Developing a novel approach to analyse the regimes of temporary streams and their controls on aquatic biota

Comments to the Editor

HESSD

8, 9637–9673, 2011

Table 3. Maximum likelihood factor loadings of the metrics analysed in Table 2.

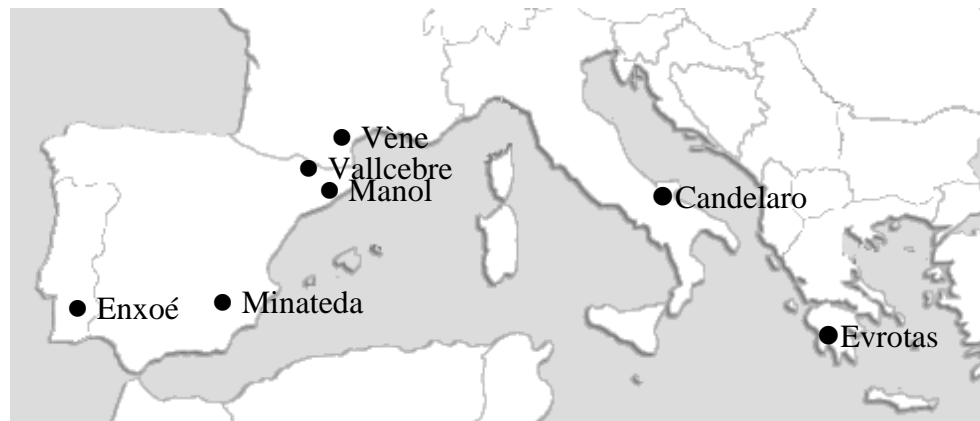
Table 3. The footnote indicates that the bold values are > 0.7. Does this mean statistical significance? Caption could be more informative.

Fig. 3. Flow duration curve for the Can Vila station, with identification of the minimum discharge thresholds that separate the diverse aquatic states.

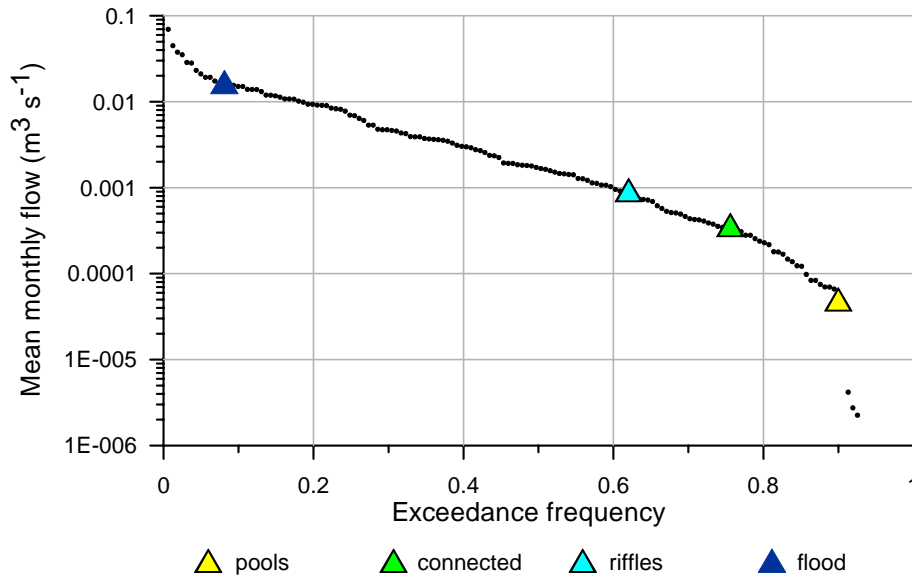
Figure 3. Reverse the order of the elements in the legend. The caption needs rewriting “Flow duration curve with the thresholds between the aquatic states identified for the Vallcebre at Can Vila site.” The thresholds are not ‘minimum discharges’ and it should not refer to them as **diverse** aquatic states. Are the three lowest values actually real measurements? The authors should settle on referring to these stations in a single fashion; they seem to jump about in the way they refer to the stations – this only confuses the reader.

Fig. 4. Aquatic states frequency graphs for the eight stream gauging stations studied.

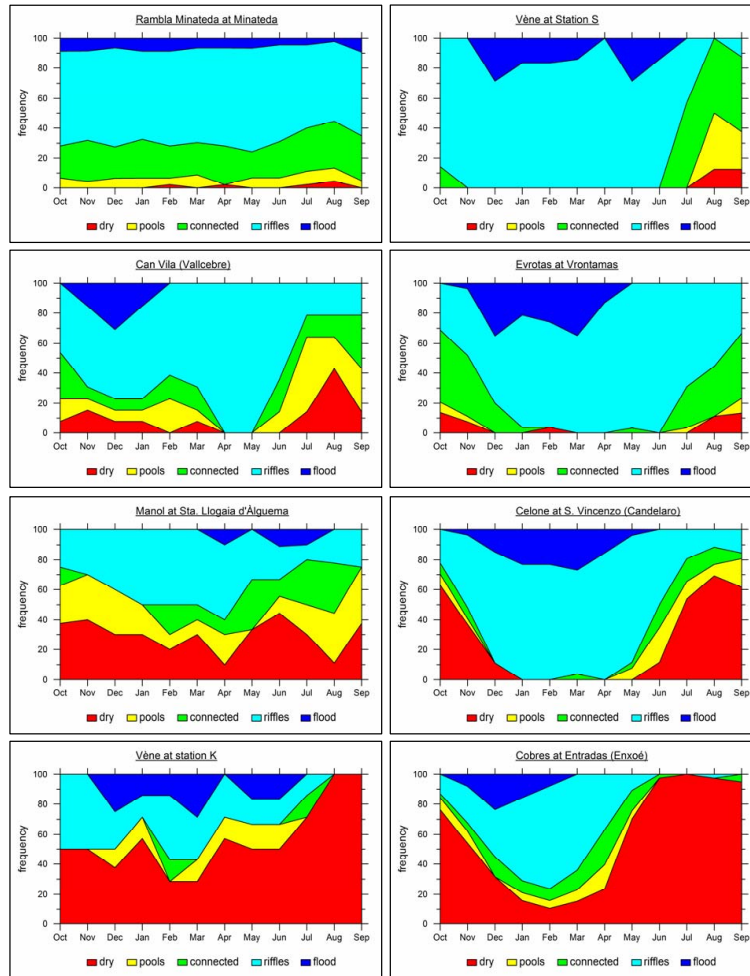
Lines 16 to 23. See the general comment about these graphs made above. The authors should consider changing these plots to they more clearly link the amount of habitat to the amount of water. Doing this should also address the issue of how the turning points are assigned to the flow duration curve.

Figure 4., Yet another method to refer to stations is used here. This form would be the one that seems most appropriate. Eg “Rambala Minateda at Minetada”. However consider the suggestions for a different format for these figures. The text suggests the basis of the layout of these figures, that should be in the caption provide for this figure.
